Access Compliance Report

Public Rights-of-Way

| Intersection ID: 48140 | Main Street: MCCAMEY_DR | Cross Street: BUTTERBURR_DR | Location: SW |
| ADA ID: 9A81AB81712A | Ramp Type: Perp | Initial Pass/Fail: Fail | Overall Compliance: No |

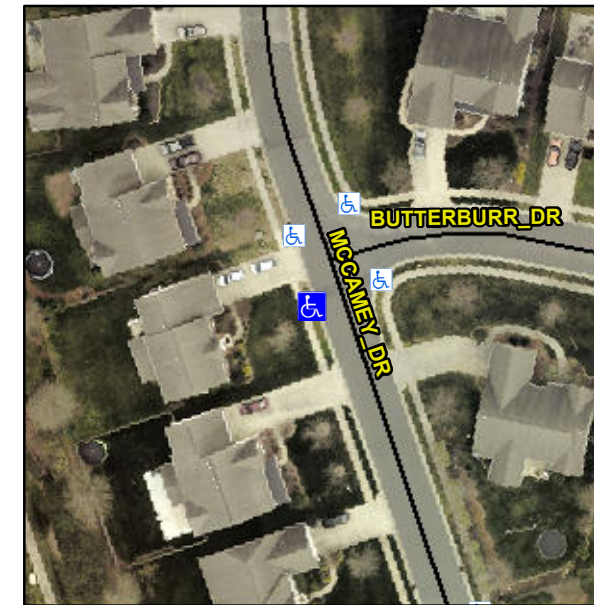
Surveyor Notes:

N/A

Not Found, R304.2.2

| Compliance | Description | Data | Compliance | Description | Data |
|------------|-----------------------|------|------------|-----------------------------|------|
| N/A | Ramp Length (in) | 47.5 | No | Ramp Slope (%) | 13.8 |

Possible Solutions:

Remove & Replace Entire Ramp.
